These amendments update the Public Service Electric and Gas Company's Nuclear Department organization, SORC responsibilities, membership, and quorum requirements.

SALEM NUCLEAR GENERATING STATION, UNIT NO. 1

AMENDMENT TO FACILITY OPERATING LICENSE

Amendment No. 62
License No. DPR-70

FIGURE 6.2-1 CORPORATE HEADQUARTERS AND OFF-SITE ORGANIZATION FOR MANAGEMENT AND TECHNICAL SUPPORT

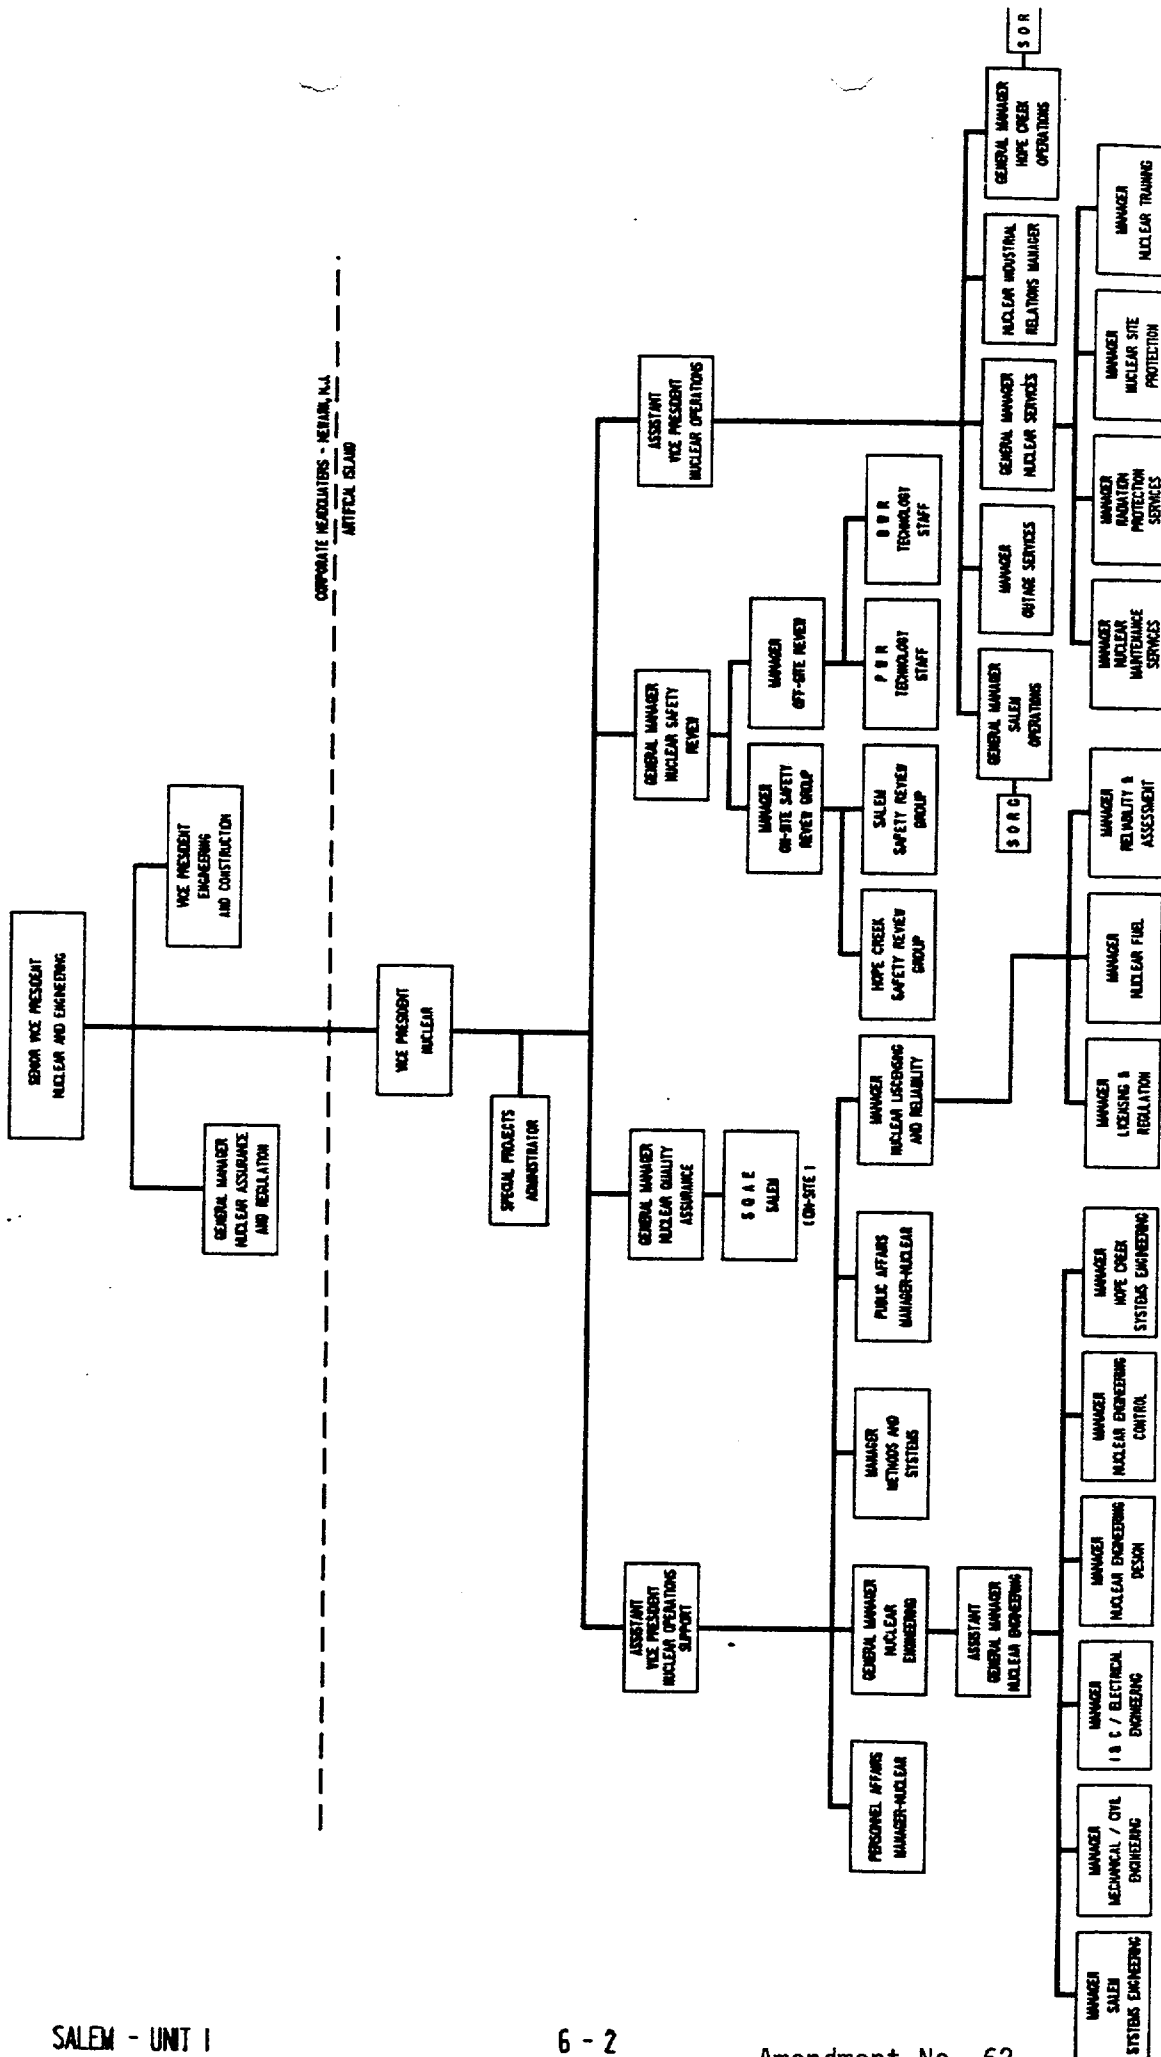
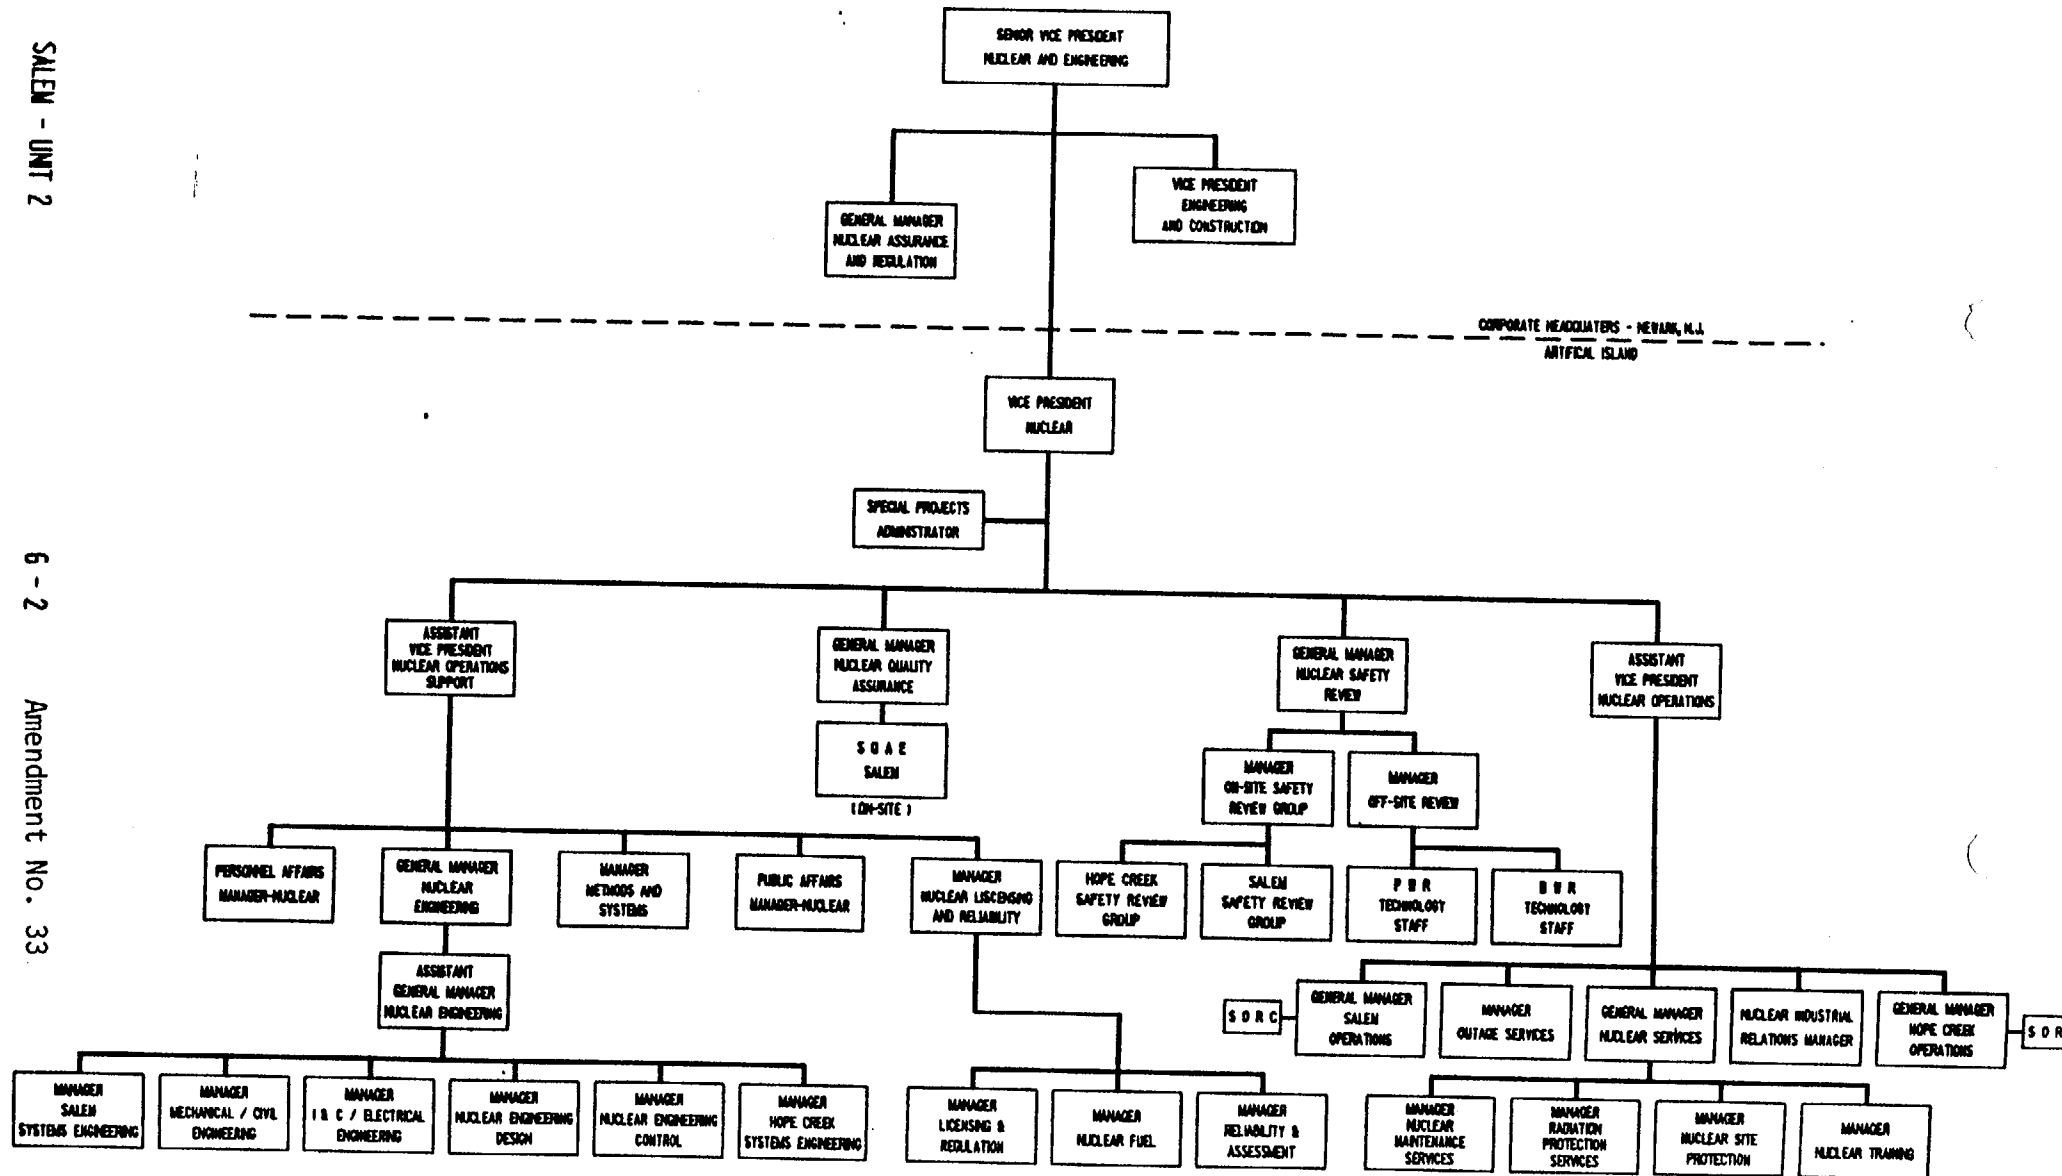
1. Figure 6.2.1 (Corporate Headquarters and Off-site Organization for Management and Technical Support). This organization has been revised to establish the new positions of Assistant Vice President Nuclear Operations Support, General Manager Nuclear Quality Assurance, General Manager Nuclear Safety Review, and Assistant Vice President Nuclear Operations, reporting to the Vice President Nuclear. This change does not delete any technical support provided to the Salem units by the

We have reviewed this change and find it meets the guidance of draft NUREG-0731, and the acceptance criteria of Section 13.1.1 of NUREG-0800, the Standard Review Plan, and is acceptable.
